**SUBDIVISION COMMITTEE
METROPOLITAN AREA PLANNING COMMISSION**

**STAFF REPORT
(Preliminary Plat)**

CASE NUMBER: S/D 98-37 - HEATHER ADDITION

STAFF REPORT
(Final Plat, Preliminary Plat approved 4/23/98)

VICINITY MAP

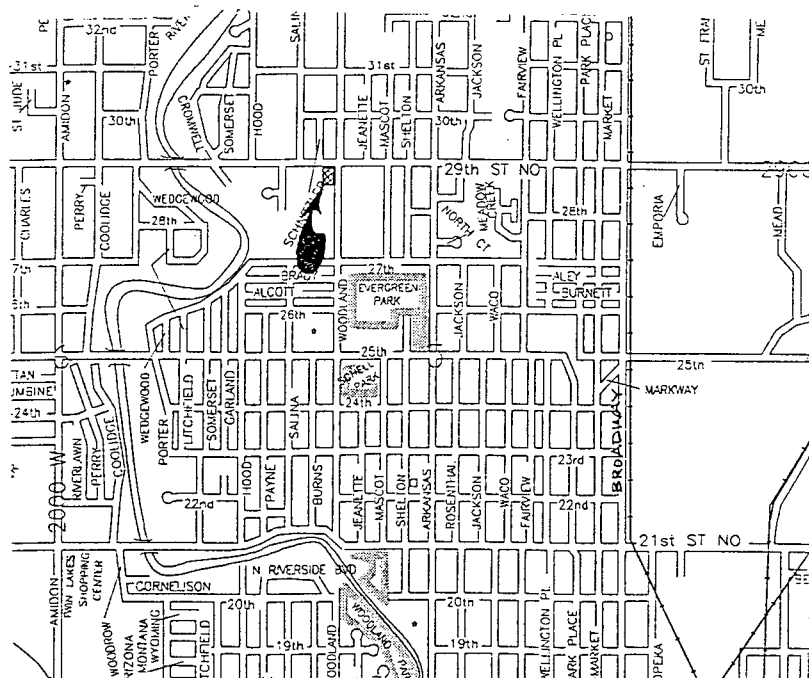
- A. Existing municipal services appear to be available to this site. **City Engineering** needs to verify if any other guarantees are required.
- B. If improvements are guaranteed by petition, a notarized certificate listing the petitions shall be submitted to the Planning department for recording.

- C. **City Engineering** needs to comment on the status of the applicant's drainage concept.
- D. **Traffic Engineering** needs to comment on the need for access controls along perimeter streets, and additional right-of-way.

- E. **Traffic Engineering** needs to comment on the need for any street improvements.
- F. This property is within a zone identified by the City Engineers' office as likely to have groundwater at some or all times within 10 feet of the ground surface elevation. Building with specially engineered foundations or with the lowest floor opening above groundwater is recommended, and owners seeking building permits on this property will be similarly advised. More detailed information on recorded groundwater elevations in the vicinity of this property is available in the City Engineers' office.

- G. The reference to Lot 4 in the legal description needs to be clarified.
- H. Lots 1 and 3 shall provide for sidewalks along Woodland Road.
- I. A restrictive covenant shall be submitted limiting the uses of lots 2, 3, and 4 to those permitted under the SF-6, Single-Family Residential district.

- J. The final plat shall reference a tie point to a section corner.
- K. The applicant shall install or guarantee the installation of all utilities and facilities which are applicable and described in Article 8 of the MAPC Subdivision Regulations. (Water service and fire hydrants required by Article 8 for fire protection shall be as per the direction and approval of the Chief of the Fire

VICINITY MAP

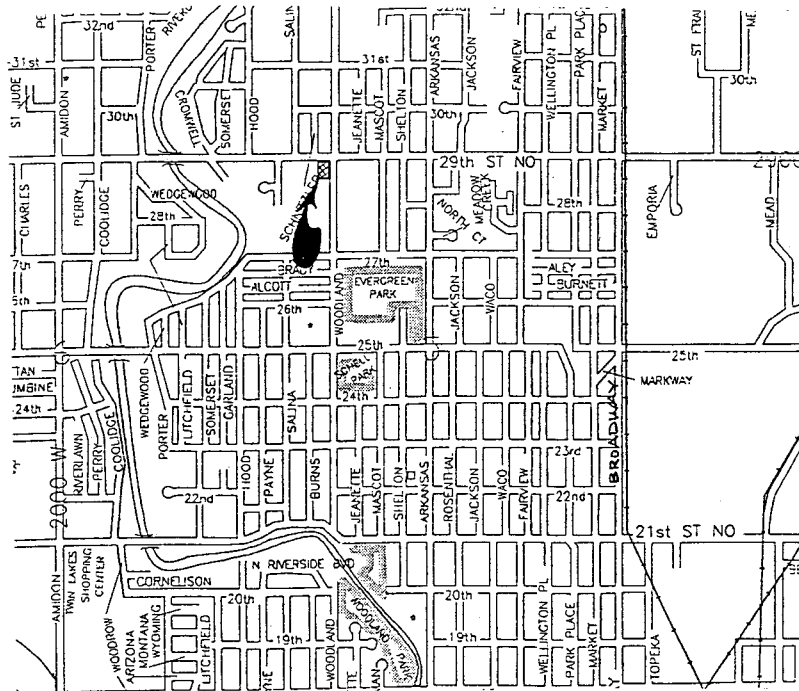
- A. Existing municipal services appear to be available to this site. **City Engineering** needs to verify if any other guarantees are required. **Woodland Street contains substandard pavement and an affidavit not to protest future paving to City standards will be required of the applicant.**
- B. If improvements are guaranteed by petition, a notarized certificate listing the petitions shall be submitted to the Planning department for recording.
- C. **City Engineering** needs to comment on the status of the applicant's drainage concept. **The drainage plan is approved. A cross-lot drainage agreement is needed or a drainage easement needed to be denoted on the plat along the western line (coinciding with the utility easement).**

- D. **Traffic Engineering** needs to comment on the need for access controls along perimeter streets, and additional right-of-way. **Traffic Engineering requests an additional 20-foot of right-of-way along 29th Street North. Complete access control along 29th Street North is required along the westernmost portion of the northern lot and the east 70 feet. Along Woodland, 50 feet of complete access control will be required from the intersection.**

- E. **Traffic Engineering** needs to comment on the need for any street improvements.
- F. This property is within a zone identified by the City Engineers' office as likely to have groundwater at some or all times within 10 feet of the ground surface elevation. Building with specially engineered foundations or with the lowest floor opening above groundwater is recommended, and owners seeking building permits on this property will be similarly advised. More detailed information on recorded groundwater elevations in the vicinity of this property is available in the City Engineers' office.

- G. The applicant needs to revise the legal description to accurately portray the land being platted. The distances on the drawing are not identical to those in the legal description.

- H. Lot 1 shall provide for sidewalks along Woodland Road. *This issue will be further reviewed at the final plat stage. The Subdivision Committee did not believe a need for this sidewalk existed if it was determined that Woodland was not a Collector street.* Woodland is not classified as a Collector Street and sidewalks will not be required.

- I. A restrictive covenant shall be submitted limiting the uses of lots ~~3~~² to those permitted under the SF-6, Single-Family Residential district.
- J. The final plat tracing shall reference a tie point to a section corner.

A drainage easement has been denoted on the plat as requested.

The additional right-of-way and access controls have been included on the final plat.
